State of Washington
POLLUTION LIABILITY INSURANCE AGENCY
PO Box 40930 • Olympia, Washington 98504-0930
(360) 407-0520 • (800) 822-3905
www.plia.wa.gov

Re: No Further Action at the Following Site:

- **Facility/Site Name:** 425 W. 2nd Ave., Spokane, WA 99204 (Former Allied Lock and Safe)
- **Facility/Site Address:** 425 W. 2nd Ave., Spokane, WA 99204
- **Facility Site ID:** 72355
- **Technical Assistance Program No.:** PEA012

Opinion on Cleanup

Figure 2: Site Plan Map

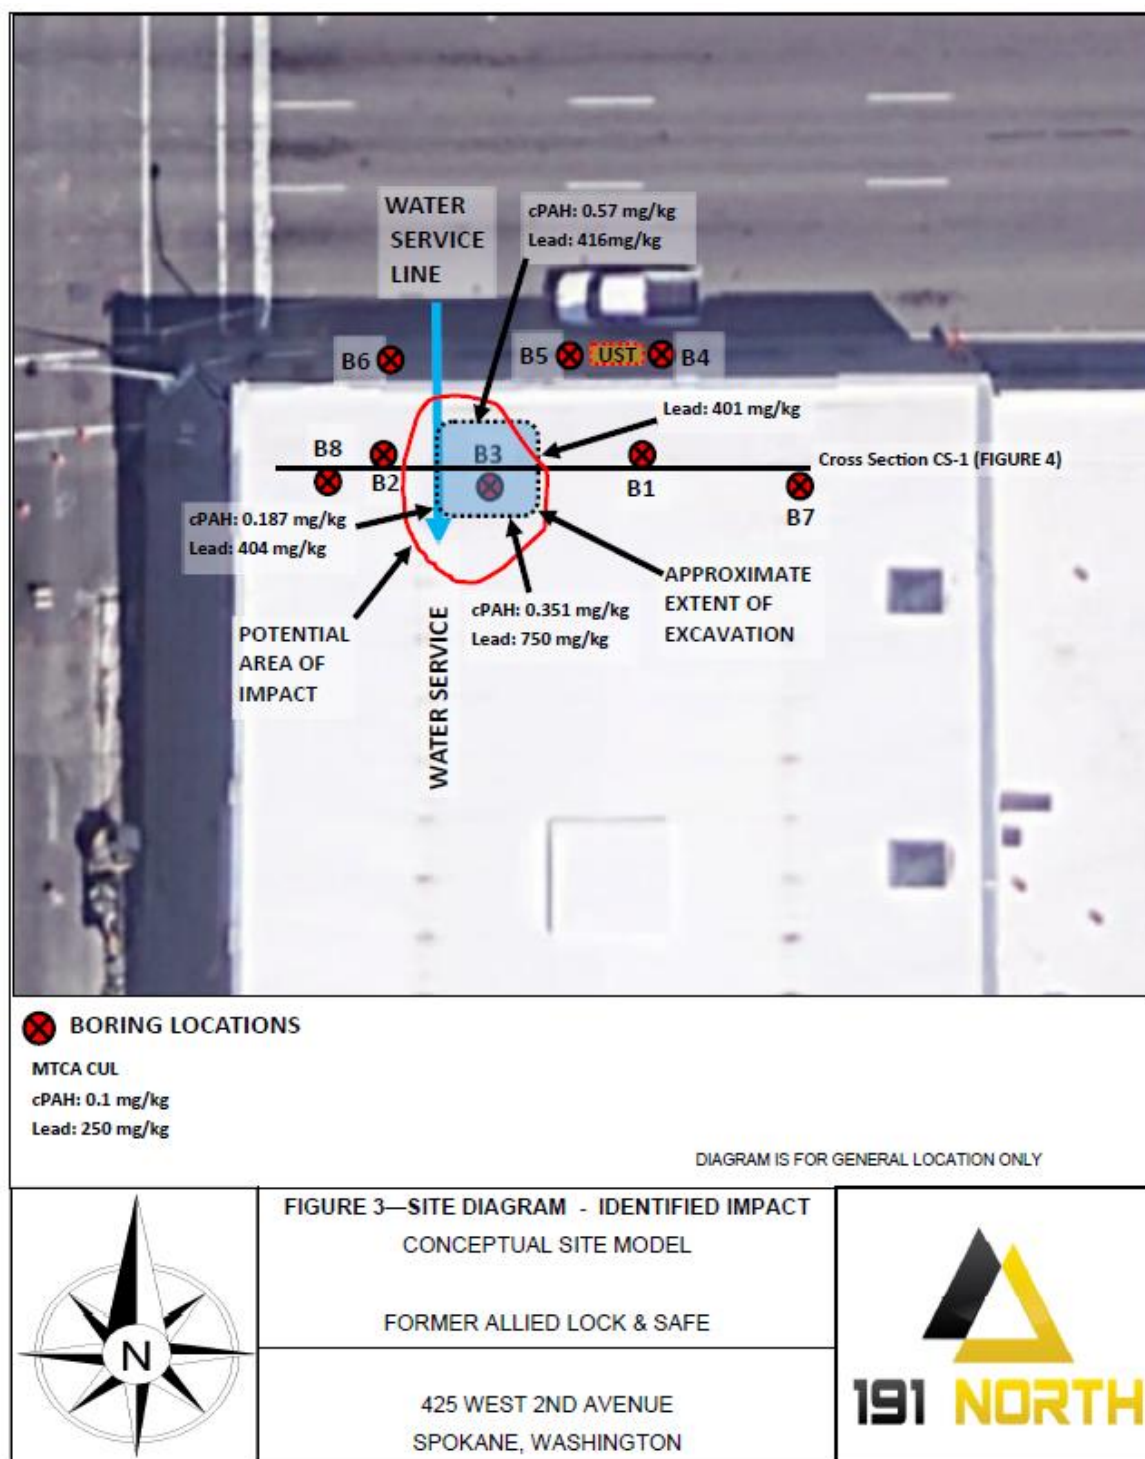
- An additional UST was found during the GPR assessment underneath the sidewalk (Figure 2) nearby in a separate "hammered" out pocket within the basalt. Investigations at the Site indicated that the UST was closed in place. In PLIA's opinion, this UST was adequately investigated with exploratory borings, subsurface soil sampling and analytical testing for Site contaminants of concern, with no detections that would indicate a release had occurred.
- Lead and cPAHs were also detected at the Site in the vicinity of the "hammered" out pocket of the suspected former UST. These contaminants are known to be ubiquitous to the area of downtown Spokane, with a high probability of being associated with a historic source that is unrelated to the TPH-g detections at the Site.

Figure 3: Extent of Petroleum Contaminated Soil (PCS)

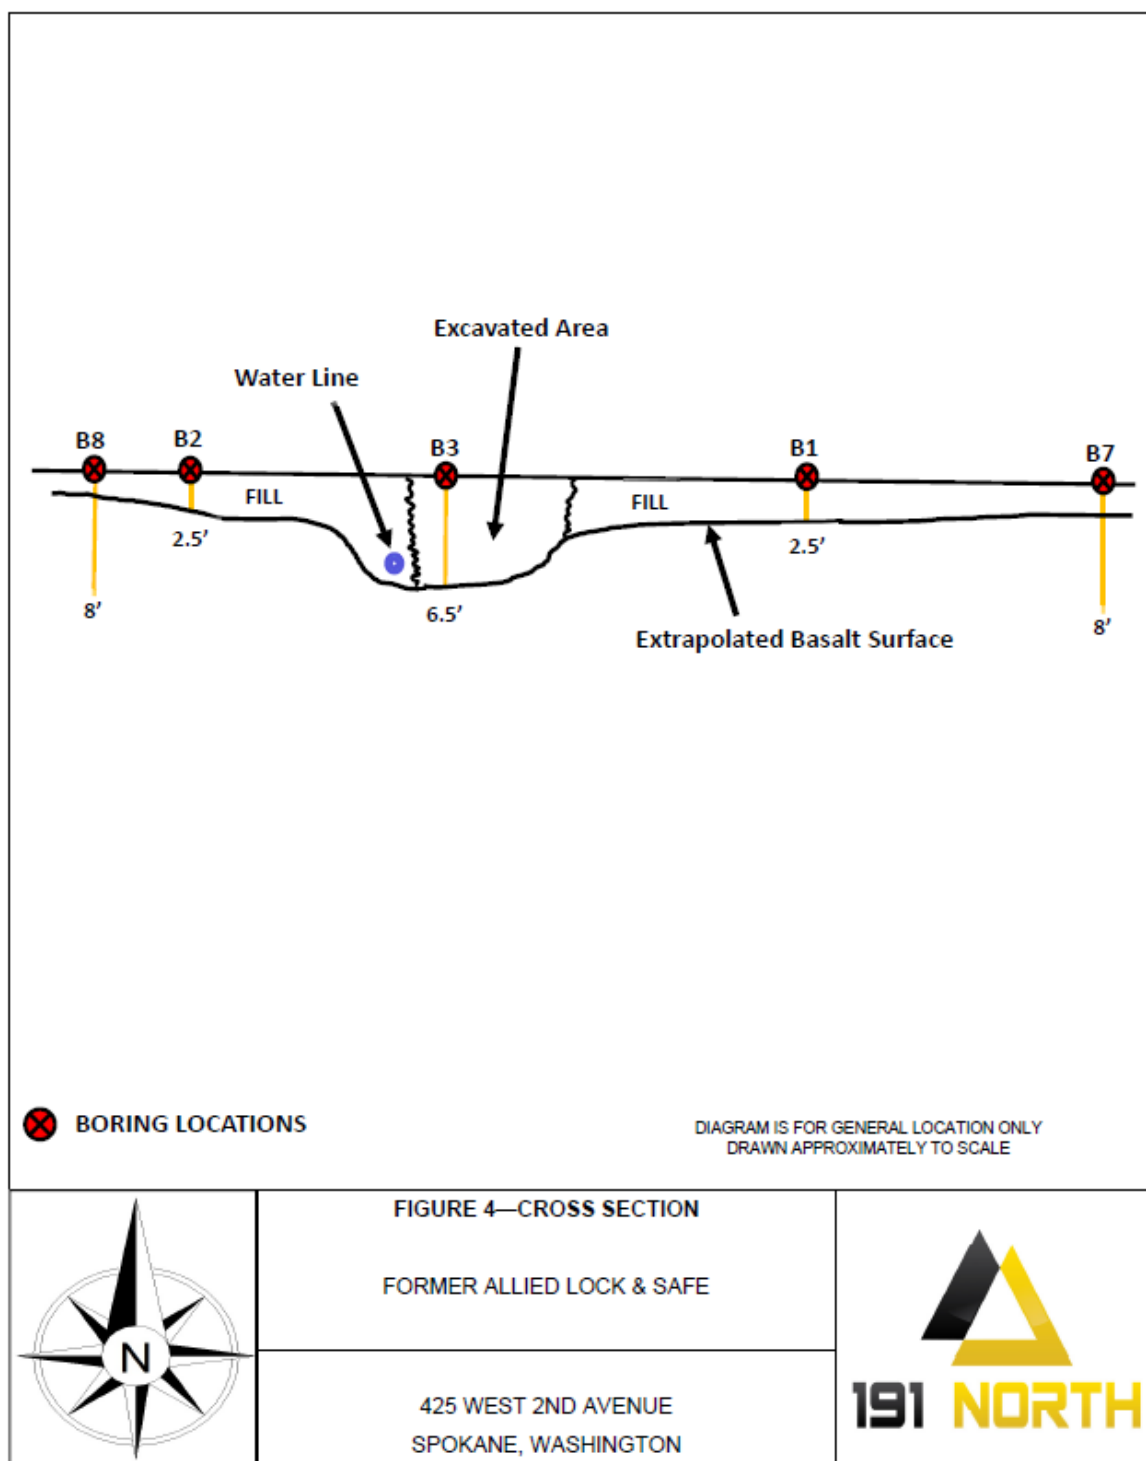
- Excavation and removal of approximately 8.5 tons of TPH-g impacted PCS was reportedly conducted at the location of the former UST, as depicted in Figures 3 and 4. Excavation was reportedly completed to the full vertical depth of the “hammered” pocket within the native basalt bedrock. Confirmation soil sampling results indicate that TPH-g and its associated volatile organic compounds (VOCs) were successfully remediated to below MTCA Method A CULs in all sidewalls. No “bottom” soil sample could be collected, as soil to the complete vertical depth had been excavated, completely to the top of the bedrock.
- Soil material impacted with lead and cPAHs were also reportedly excavated and removed to the maximum extent technically practicable. Inaccessible soil impacted by lead and cPAHs reportedly remain on the
